#	Sheet Name	Sheet Issue Date	Current Revision
A000	COVER SHEET	03.14.22	
A011	LEGENDS	03.14.22	
A012	LOT AREA PLAN	03.14.22	
A020	GFA AREA DIAGRAMS EXISTING	03.14.22	
A021	GFA AREA DIAGRAMS PROPOSED	03.14.22	
A100	PROPOSED PLANS - 3/16 SCALE	03.14.22	
A105	EXISTING AND PROPOSED ROOF PLANS	03.14.22	
A201	EXISTING & PROPOSED ELEVATIONS	03.14.22	
A202	EXISTING & PROPOSED ELEVATIONS	03.14.22	
A203	EXISTING AND PROPOSED ELEVATIONS	03.14.22	
A301	BUILDING SECTION	03.14.22	
A310	UNIT 1 - STAIR SECTION AND ENLARGED PLANS	03.14.22	
A311	UNIT 2 - STAIR SECTION AND ENLARGED PLANS	03.14.22	
A401	WALL TYPES	03.14.22	
A402	FIRE RATED ASSEMBLIES	03.14.22	
A501	WINDOW ELEVATIONS & SCHEDULE	03.14.22	
S100	FRAMING PLANS	03.10.22

17 ALVESTON STREET, JAMAICA PLAIN MA  
 PERMIT PLAN  
 03.14.22

title COVER SHEET  
 project 17 ALVESTON STREET, JAMAICA PLAIN MA

file  
**EXISTING AND PROPOSED BASEMENT PLANS**  
project  
**17 ALVESTON STREET, JAMAICA PLAIN MA**

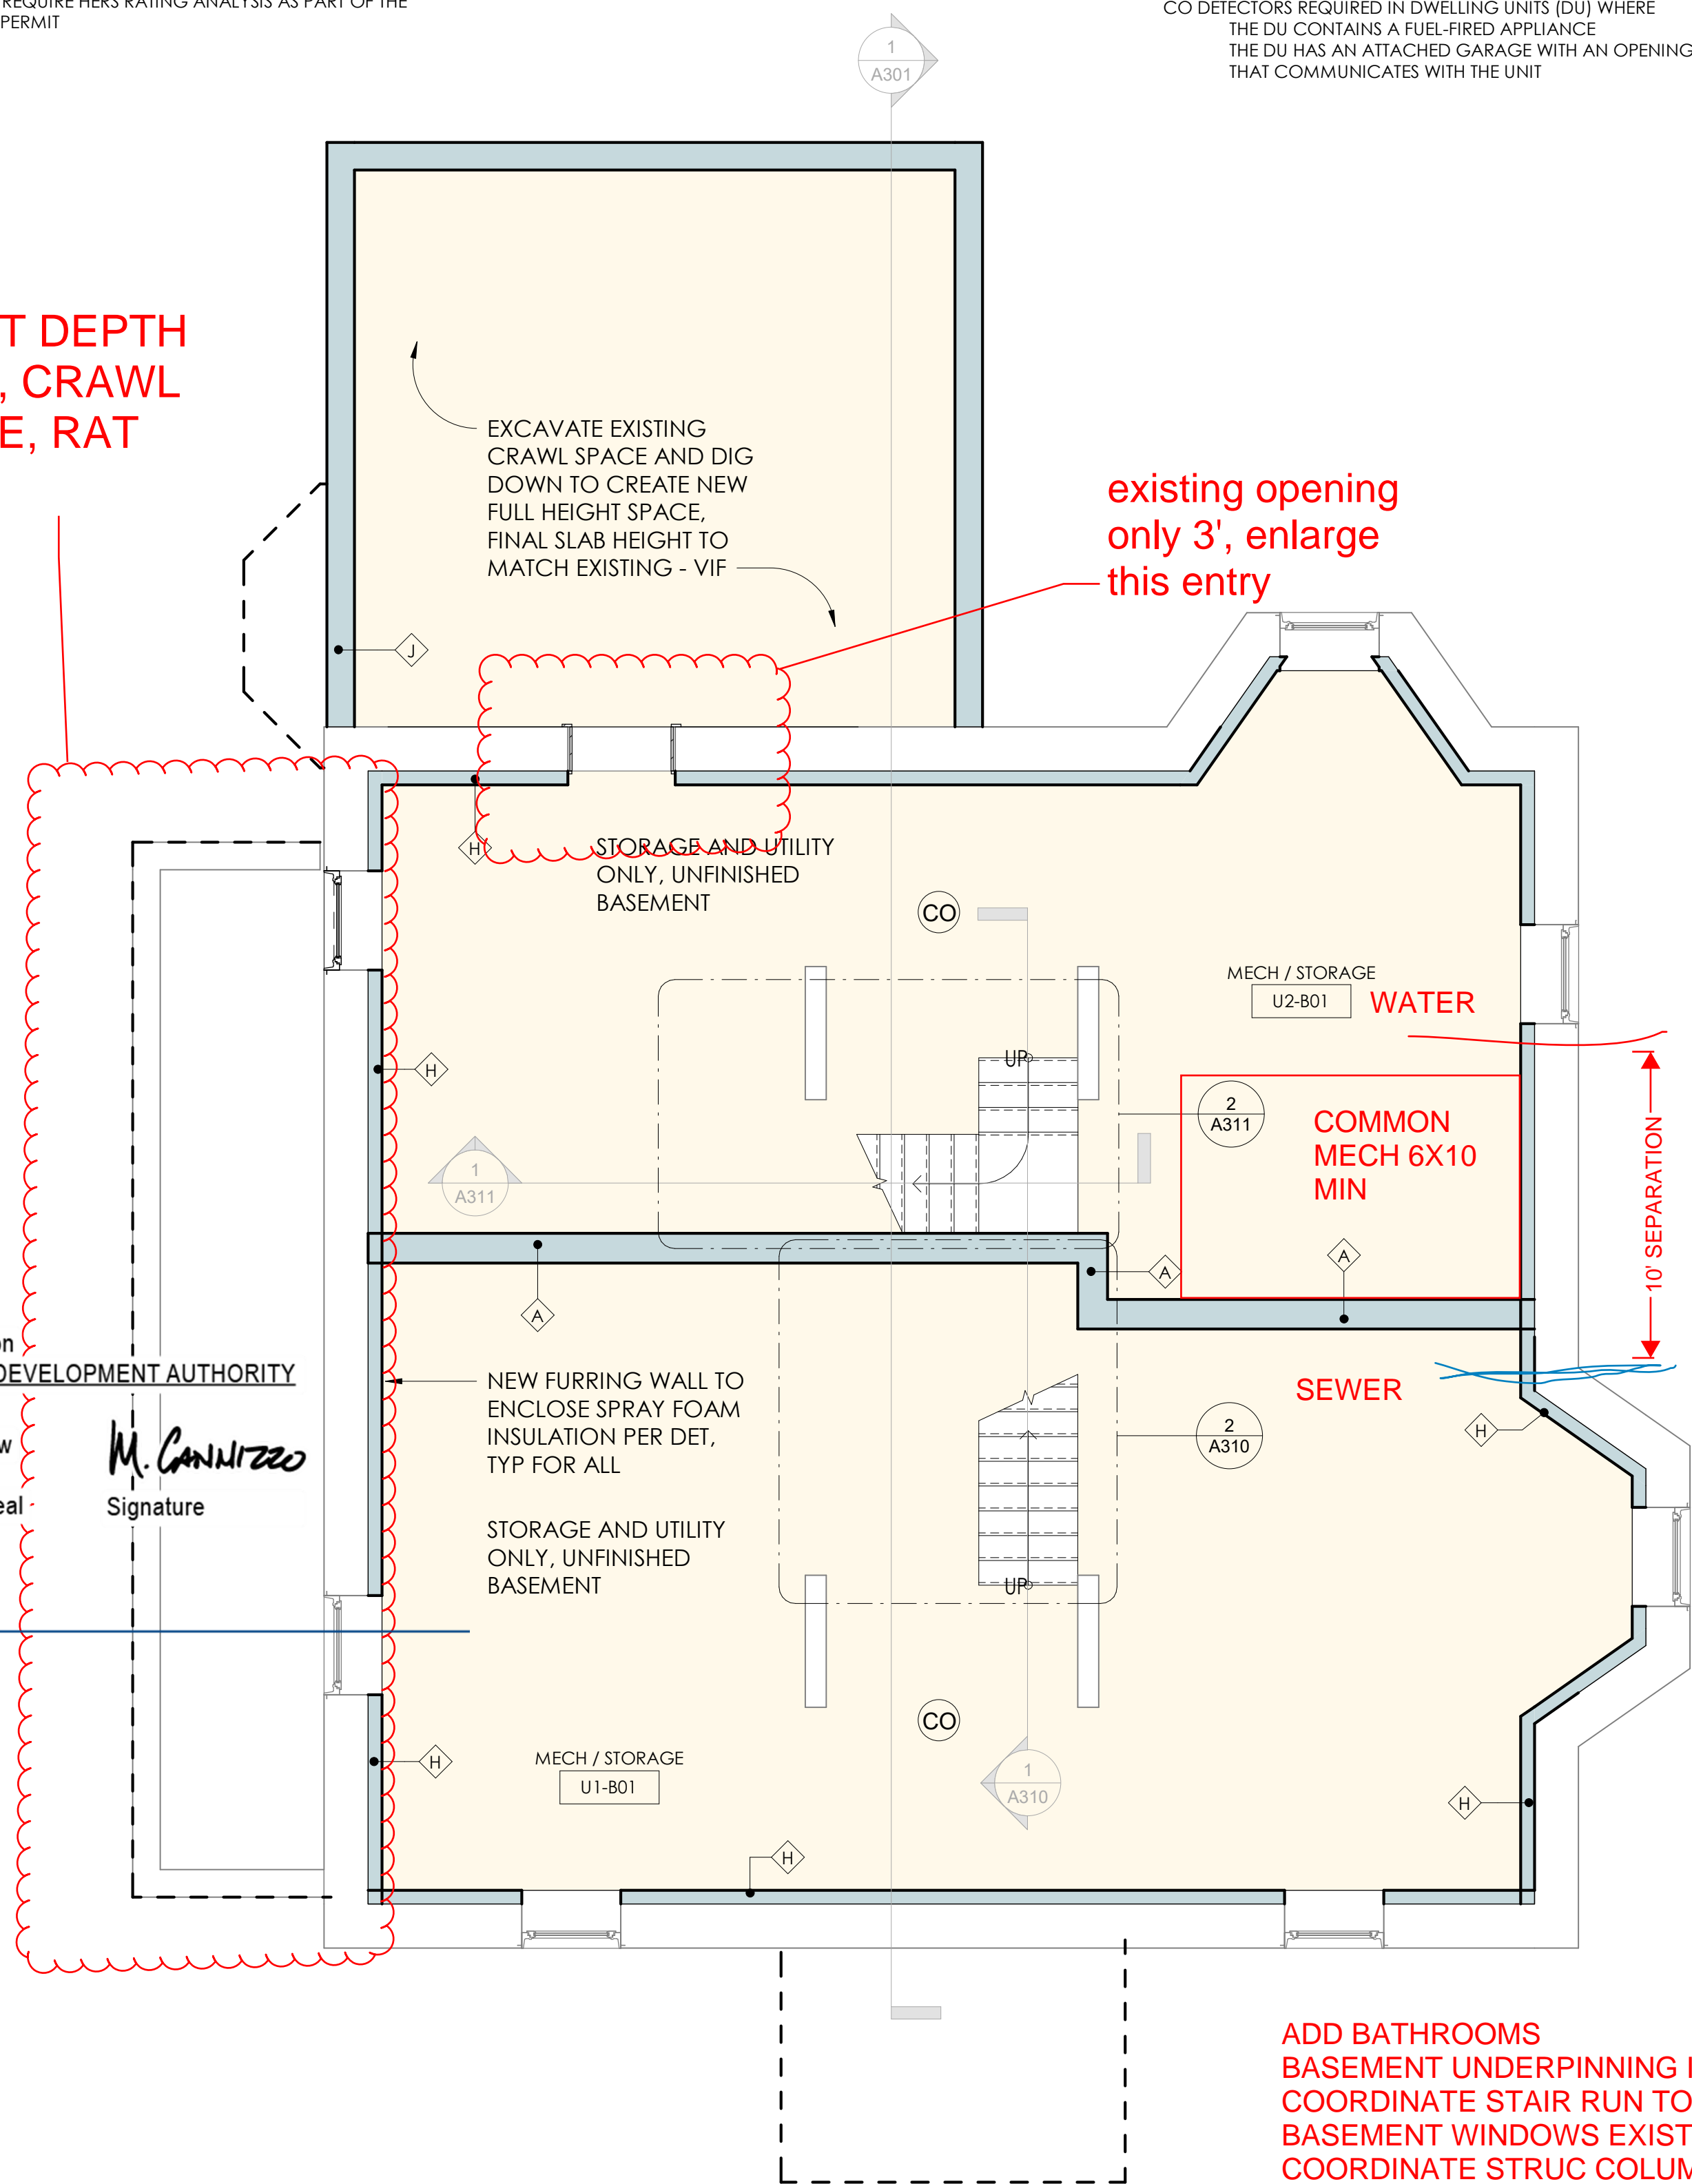
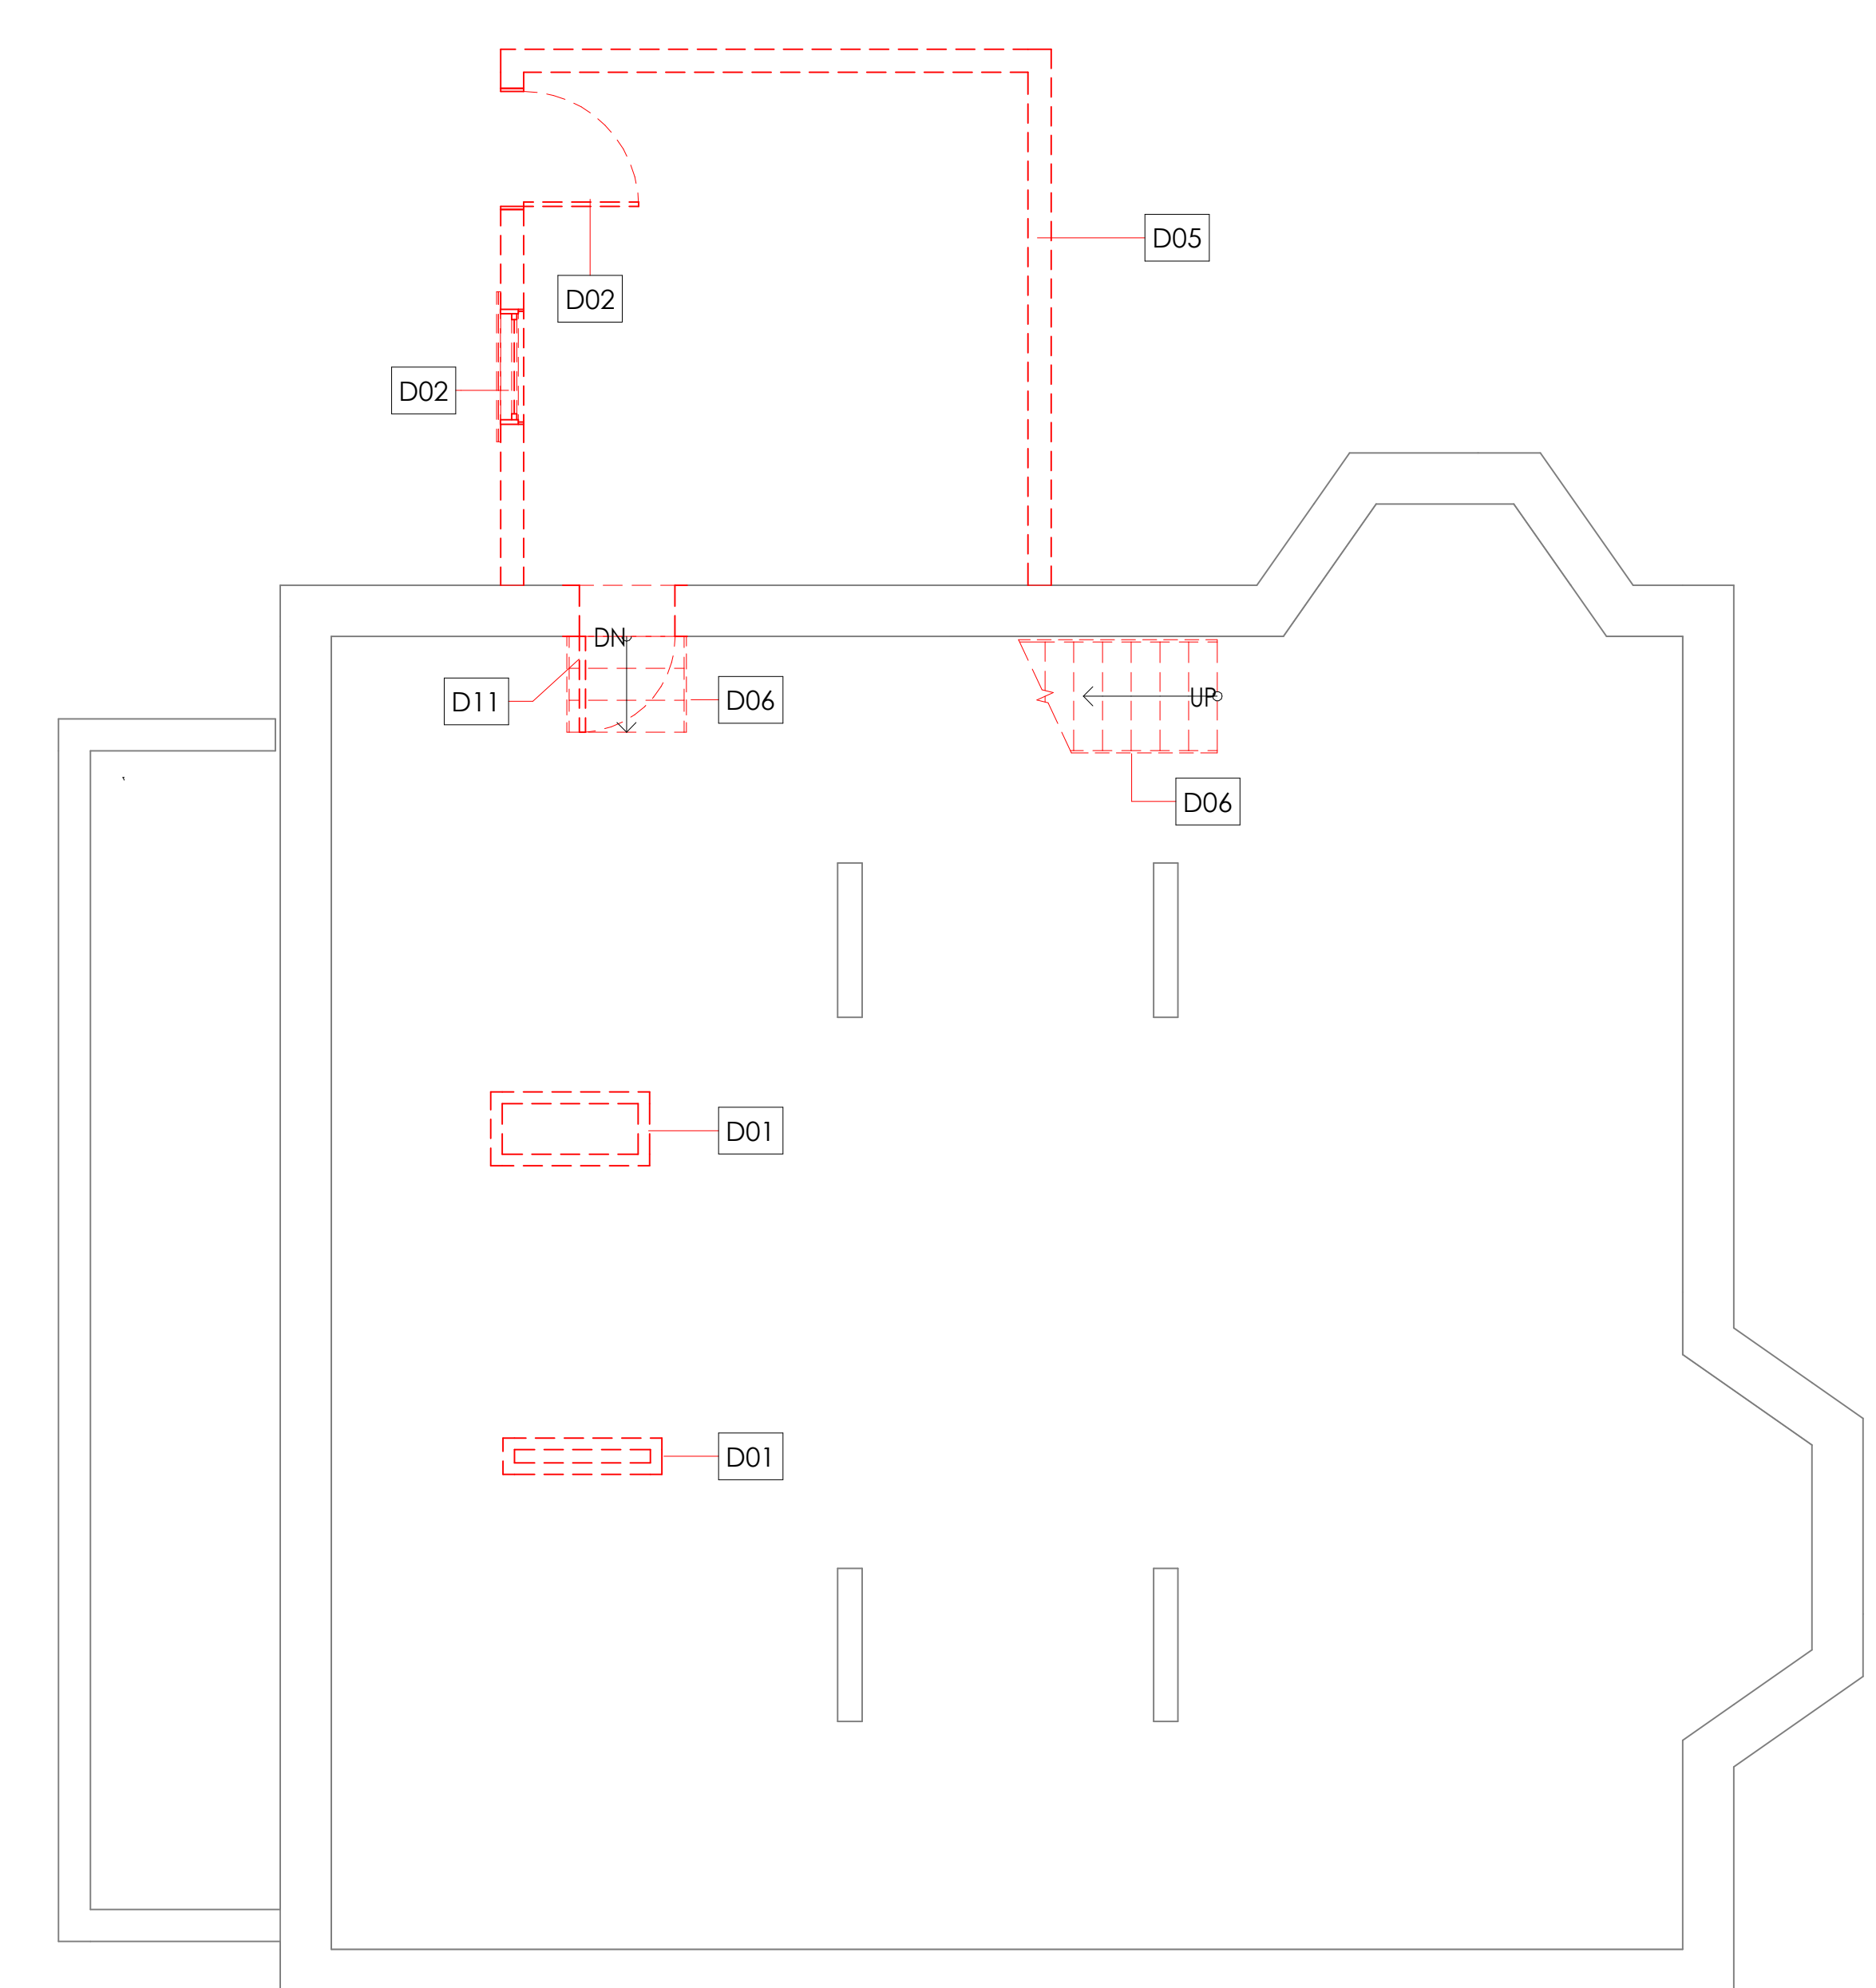
existing opening only 3', enlarge this entry

**ADD BATHROOMS BASEMENT UNDERPINNING IN SECTIONS MAX OUT 3' COORDINATE STAIR RUN TO BASEMENT, BASEMENT WINDOWS EXISTING COORDINATE STRUC COLUMN LOCATIONS**
